Response to Request for Continuing Examination SN 09/513,768 Bernard E. Souw – Patent Examiner AU 2881

January 15, 2004

The following is a response to Applicant's arguments against the key analysis provided in the Appendix attached to the May 7 Advisory Action.

Fig.1 (from ref.[5])

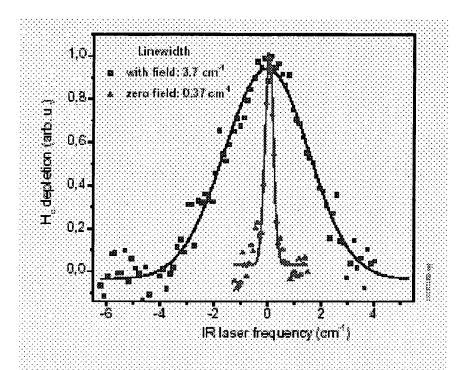
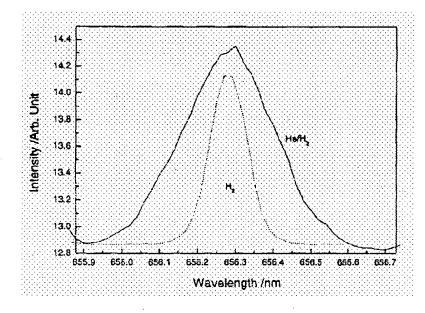
Secondly, and *most importantly*, anomalous hydrogen line broadening is not at all an evidence for the existence of hydrino, because it is well known in the art that such a broadening may be caused by many other conventional mechanisms, such as microwave plasma effects, the latter having not been considered by Applicant. Instead, such an effect has been sofar ignored or dismissed by Applicant without any valid reason. The measured excessive linewidth shown in Applicant's Fig.6 of ref.[6], i.e., 0.27 nm, is about the same magnitude as what is measured by other authors, e.g., ref.[5] cited in the May 7 Appendix, here reproduced in Fig.1 below.

As shown in Fig.[1], the anomalous line width of 0.16 nm, measured in a microwave discharge similar to Applicant's under the same gas mixture and pressure range, is about 10 times the Doppler width, and has been attributed to microwave plasma effects. Applicant's previous criticism on this reference [5] is unjustified. The paper was a conference publication posted by a research group from the University of Essen, Germany. It is not a lone-standing unrefereed paper as alleged by Applicant, but instead, supported by a large number of experimental and theoretical works, as listed at the end of the paper. It would have been extremely doubtful to one of ordinary skill in the art if any cause other than the RF/microwave field itself should be held responsible for an effect that is only and exclusively observed in RF/microwave plasmas.

Thus, Applicant's "excessive line broadening" is not at all an evidence for Applicant's hypothetical "hydrino", but rather, a conventional effect that has been already observed by other authors, as evidenced in Fig.1. Such a high frequency Stark effect has <u>never</u> been considered in any of Applicant's numerous reports on "anomalous" or "excessive" line broadening. Instead, Applicant always assumes that Doppler effect were the main cause, as clearly stated on pp. 6-7 of Applicant's Appendix attached to the RCE. The assumption of Doppler effect as a main mechanism for Applicant's line broadening has been known as incorrect for RF and microwave plasmas, as discussed above. Applicant's misassumption of this line-broadening mechanism automatically disqualifies all Applicant's arguments based on anomalous or excessive line broadening in microwave plasmas.

Applicant's statement on page 6, that "The Examiner does not present any alternative explanation for the cited data", is doubly unpersuasive. Firstly, alternative explanation was readily provided by the result shown in Fig.1, which has been explicitly cited in the previous May 7 Appendix [5].
